**Draft amendment [2],
as updated in the informal working group meeting
of 16 – 17 December 2013**

Submitted by the informal working group on global technical regulation No. 9

The text reproduced below is presented by the pedestrian safety experts of the IWG on gtr No. 9 – Phase 2. It represents the outcome of discussion in their 9th meeting, held on 16 – 17 December 2013 in Geneva. The modifications to the text of the global technical regulation are marked in bold for new or strikethrough for deleted characters, tracked changes represent the changes to document UNECE/TRANS/WP.29/GRSP/2013/25.

Flexible lower legform impactor: Dimensions and centre of gravity locations of femur, knee joint and tibia (side view)

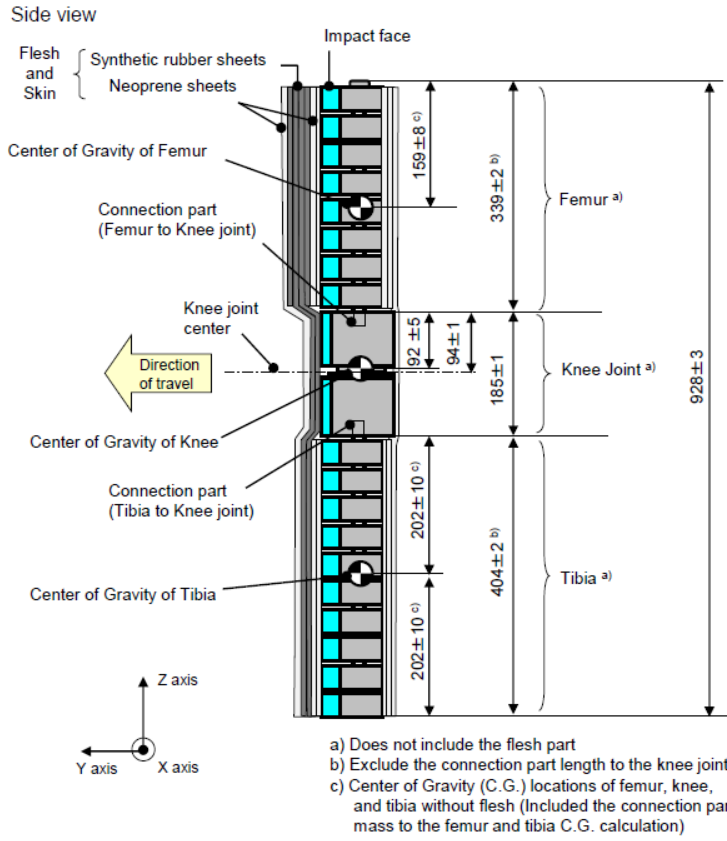
The flexible lower legform impactor shall consist of the flesh and skin, the flexible long bone segments (representing the femur and the tibia), and the knee joint as shown in Figure 12.

The centres of gravity of the femur and tibia without the flesh and skin, including the connection parts to the knee joint, shall be 159 ± 8 mm and 202 ± 10 mm respectively from the top, but not including the connection part to the knee joint, of each part as shown in Figure 12. The centre of gravity of the knee joint shall be 92 ± 5 mm from the top of the knee joint as shown in Figure 12.

Figure 13
Flexible lower legform impactor: Schematic plan views of femur, tibia, and knee dimensions (top view)

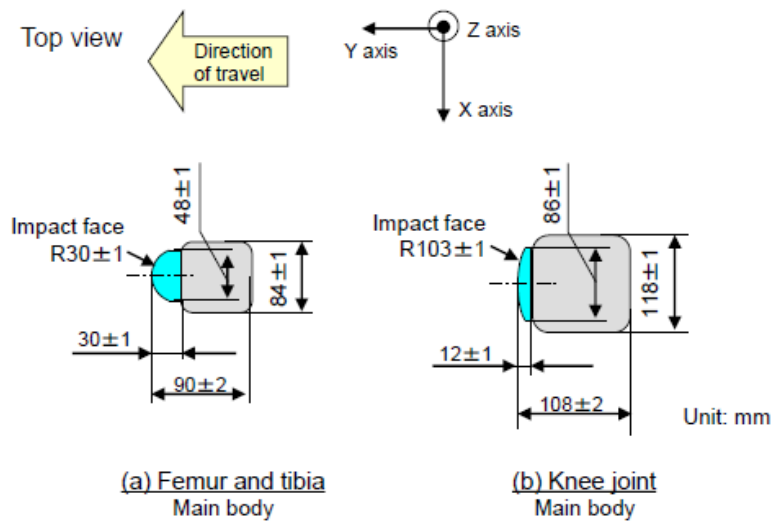
6.3.1.1.1. **The cross-sectional shape perpendicular to the Z-axis of the femur and the tibia main body segments shall be 90 mm in width along the Y-axis, and 84 mm in width along the X-axis as shown in Figure 13 (a). The impact face shall be 30 mm in radius, 30 mm in width along the Y-axis, and 48 mm in width along the X-axis as shown in Figure 13 (a).**

6.3.1.1.2. **The cross-sectional shape perpendicular to the Z-axis of the knee joint shall be 108 mm in width along the Y-axis, and 118 mm in width along the X-axis as shown in Figure 13 (b). The impact face shall be 103 mm in radius, 12 mm in width along the Y-axis, and 86 mm in width along the X-axis as shown in Figure 13 (b).**

Figure 14
Flexible lower legform impactor: Flesh and skin dimensions

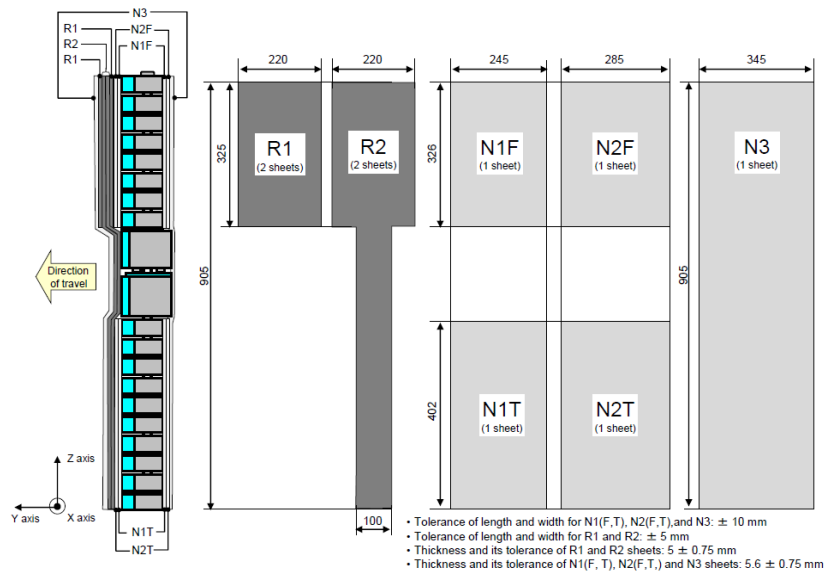
- 6.3.1.1.4. For each test, the impactor (femur, knee joint and tibia) shall be covered by the flesh and skin composed of synthetic rubber sheets (R1, R2) and neoprene sheets (N1F, N2F, N1T, N2T, N3) as shown in Figure 14. The size of the sheets shall be within the requirements described in Figure 15. The sheets are required to have compression characteristics as shown in Figure 15. The compression characteristics shall be checked using material from the same batch as the sheets used for the impactor flesh and skin.

Figure 15
Flexible lower legform impactor: Flesh and skin compression characteristics

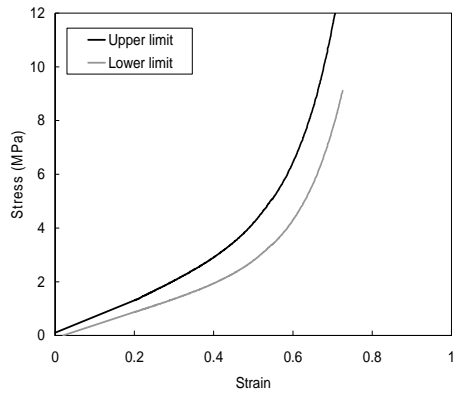
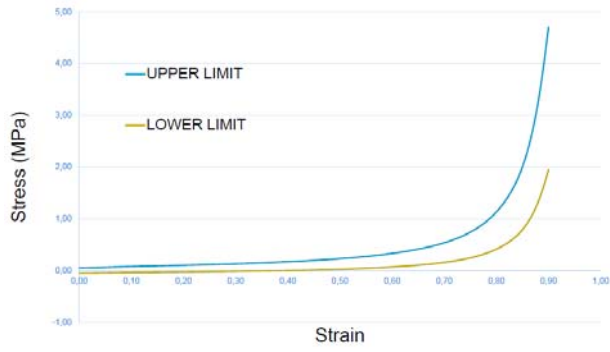
- 8.1.1.5. **The ends of the knee joint shall be mounted to the support rig firmly as shown in Figure 26. The Y-axis of the impactor shall be parallel to the loading axis within $\pm 2^\circ$ tolerance. To obtain repeatable loading, low friction Polytetrafluoroethylene (PTFE) plastic pads are used under each support (see figure 26). To avoid impactor damage, a neoprene sheet shall be set underneath the loading ram and the impactor face of the knee joint which is described in the Figure 13 shall be removed. The neoprene sheet used in this test shall have compression characteristics as shown in Figure 15.**

Figure 16
Flexible lower legform impactor; Instrument

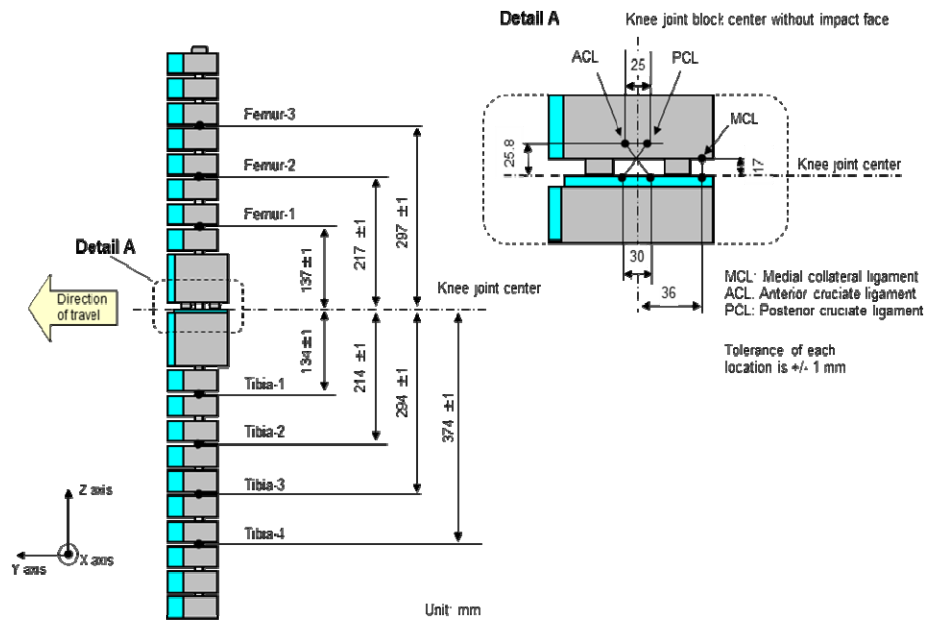
- 6.3.1.1.6.1. **Four transducers shall be installed in the tibia to measure bending moments at locations within the tibia. The sensing locations of each of the transducers are as follows: tibia-1: 134 mm, tibia-2: 214 mm, tibia-3: 294 mm and tibia-4: 374 mm below the knee joint centre respectively as shown in Figure 16.**

Three transducers shall be installed in the femur to measure bending moments applied to the femur. The sensing locations of each of the transducers are as follows: femur-1: 137 mm, femur-2: 217 mm and femur-3: 297 mm above the knee joint centre, respectively, as shown in Figure 16.

"Figure 20

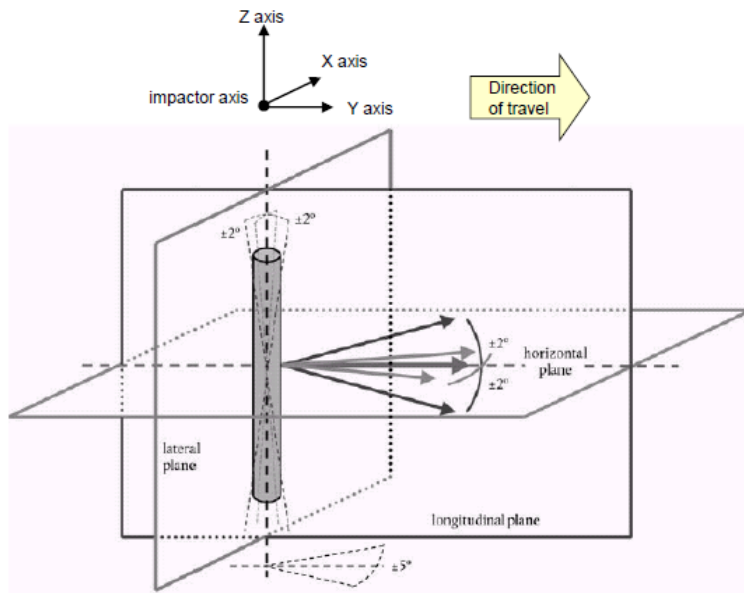
7.1.1.2. **The direction of the impact velocity vector shall be in the horizontal plane and parallel to the longitudinal vertical plane of the vehicle. The tolerance for the direction of the velocity vector in the horizontal plane and in the longitudinal plane shall be $\pm 2^\circ$ at the time of first contact. The axis of the impactor shall be perpendicular to the horizontal plane, with a roll and pitch angle tolerance of $\pm 2^\circ$ in the lateral and longitudinal plane. The horizontal, longitudinal and lateral planes are orthogonal to each other (see Figure 20).**

- 7.1.1.3.2. **At the time of first contact the impactor shall have the intended orientation about its vertical axis, for the correct operation of its knee joint, with a yaw angle tolerance of $\pm 5^\circ$ (see Figure 20).**

Figure 21

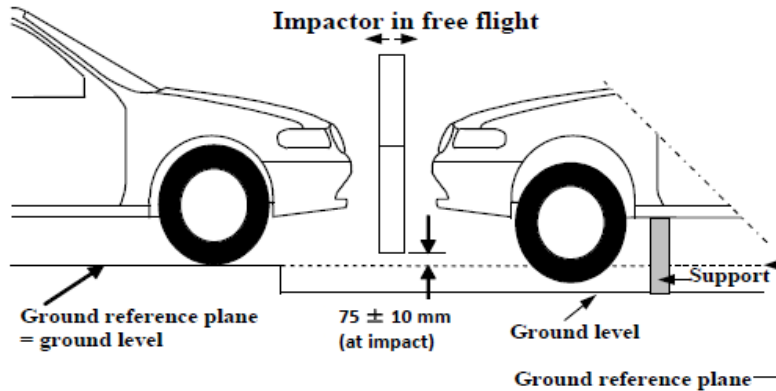
7.1.1.3. **The bottom of the impactor (without parts needed for the purposes of launching and/or protection) shall be 75 mm above the ground reference plane at the time of the first contact with the bumper (see Figure 21), with a tolerance of ± 10 mm. When setting the height of the propulsion system, an allowance must be made for the influence of gravity during the period of free flight of the impactor.**

Figure 22

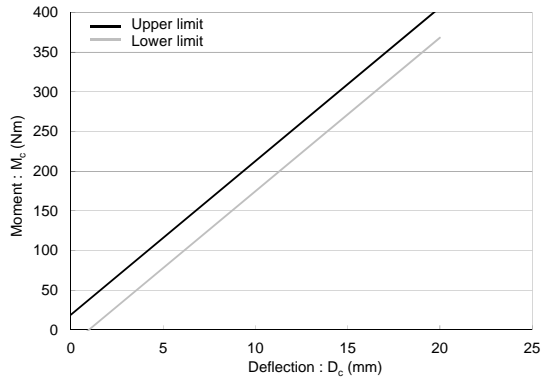
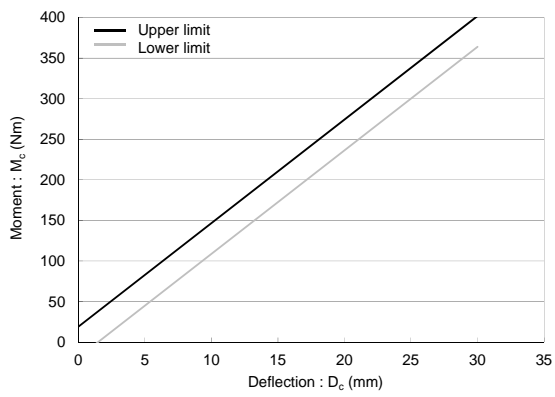
- 8.1.1.2. **When the femur and the tibia of the impactor are loaded in bending in accordance with paragraph 8.1.1.4, the applied moment and the generated deflection at the centre of the femur and the tibia (M_c and D_c) shall be within the corridors shown in Figure 22.**

Figure 23
Flexible lower legform impactor: Requirement corridors for the knee joint in the static certification test (see paragraph 8.1.1.3.)

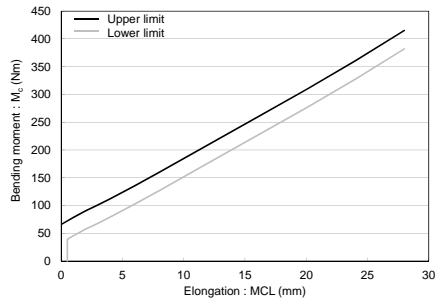
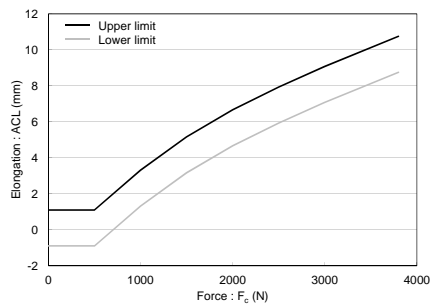
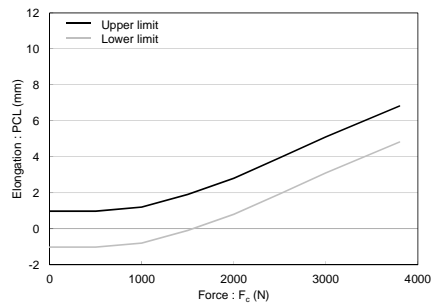
- 8.1.1.3. **When the knee joint of the impactor is loaded in bending in accordance with paragraph 8.1.1.5., the MCL, ACL, and PCL elongations and applied bending moment or the force at the centre of the knee joint (M_c or F_c) shall be within the corridors shown in Figure 23.**

Figure 24
Flexible lower legform: Impactor test set-up for the femur in the static certification test (see paragraph 8.1.1.4.)

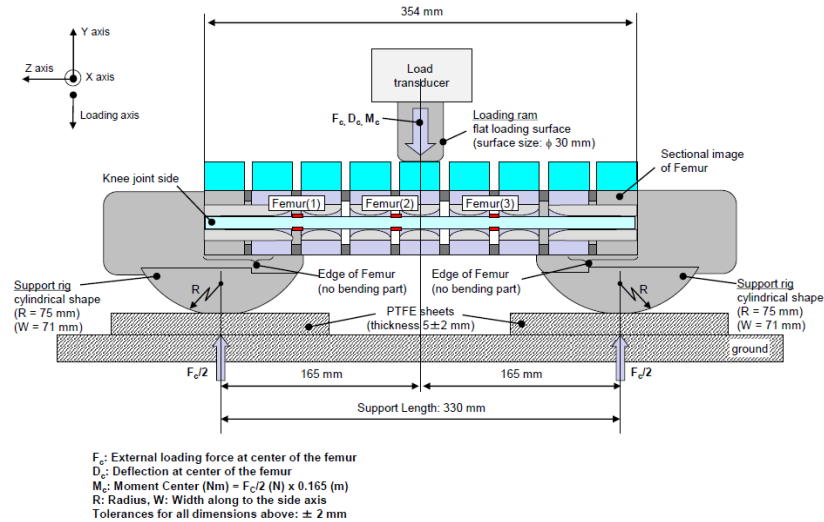
- 8.1.1.4. **The edges of the femur and tibia, not bending parts, shall be mounted to the support rig firmly as shown in Figure 24 and Figure 25. The Y-axis of the impactor shall be parallel to the loading axis within $180 \pm 2^{\circ}$ tolerance. To obtain repeatable loading, low friction Polytetrafluoroethylene (PTFE) plastic pads are used under each support (see Figure 24 and Figure 25).**

Figure 27
Flexible lower legform impactor: Test set-up for the dynamic lower legform impactor certification test (pendulum test, see paragraph 8.1.2.4.)

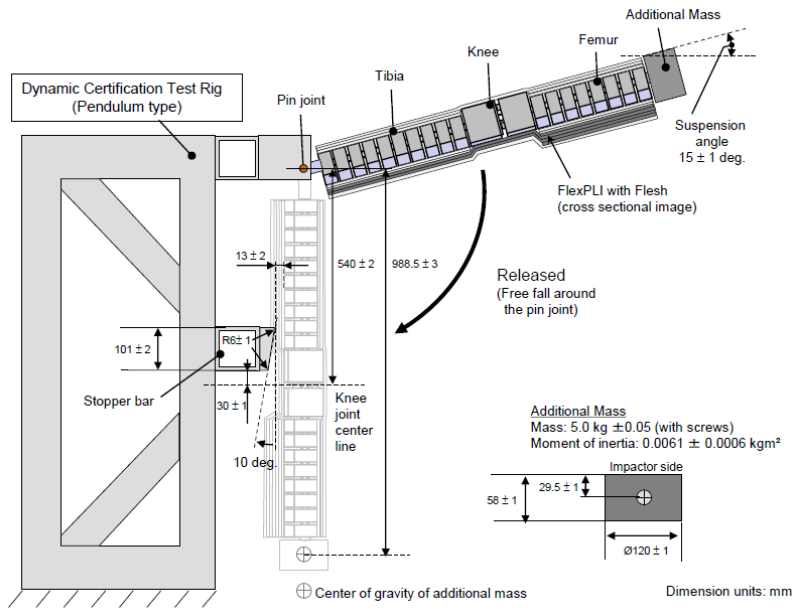
8.1.2.4.1. **The flexible lower legform impactor, including the flesh and skin, shall be suspended from the dynamic certification test rig $15 \pm 1^\circ$ upward from the horizontal as shown in Figure 27. The impactor shall be released from the suspended position and fall freely against the pin joint of the test rig as shown in Figure 27.**

- 8.1.2.4.2. **The knee joint centre of the impactor shall be 30 ± 1 mm below the bottom line of the stopper bar, and the tibia impact face without the flesh and skin shall be located 13 ± 2 mm from the front upper edge of the stopper bar when the impactor is hanging freely as shown in Figure 27.**

Figure 28
Flexible lower legform impactor: Test set-up for the dynamic lower legform impactor certification test (inverse test, see paragraph 8.1.3.4.)

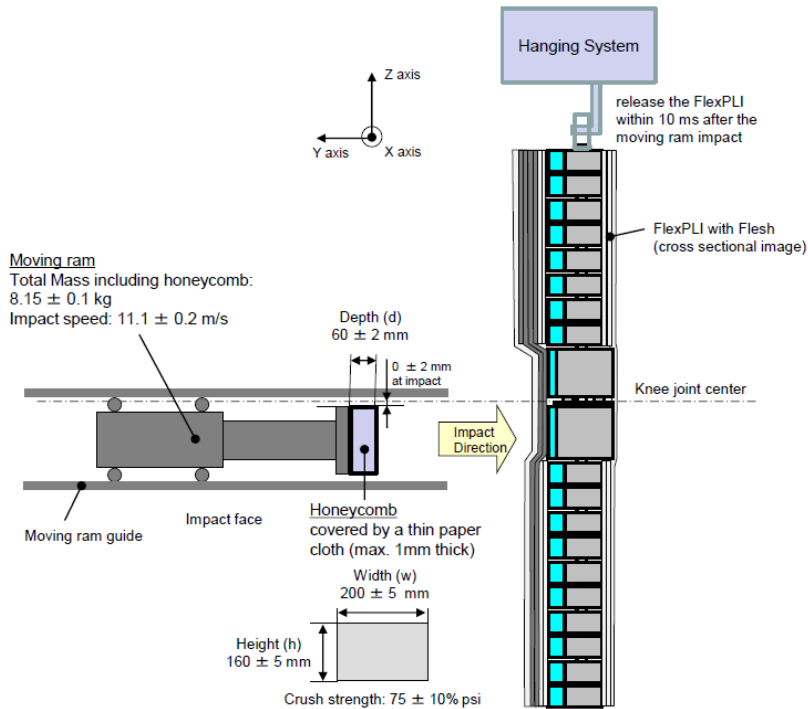
- 8.1.3.4. Test procedure
- 8.1.3.4.1. The assembled flexible lower legform impactor (with the flesh and skin) shall be hung vertically and freely suspended from a test rig as shown in Figure 28. It is then impacted by the upper edge of a linearly guided aluminium honeycomb impactor, covered by a thin paper cloth with a maximum thickness of 1 mm, at an impact speed of 11.1 ± 0.2 m/s. The legform shall achieve a free flight condition within 10 ms after the time of first contact of the honeycomb impactor.
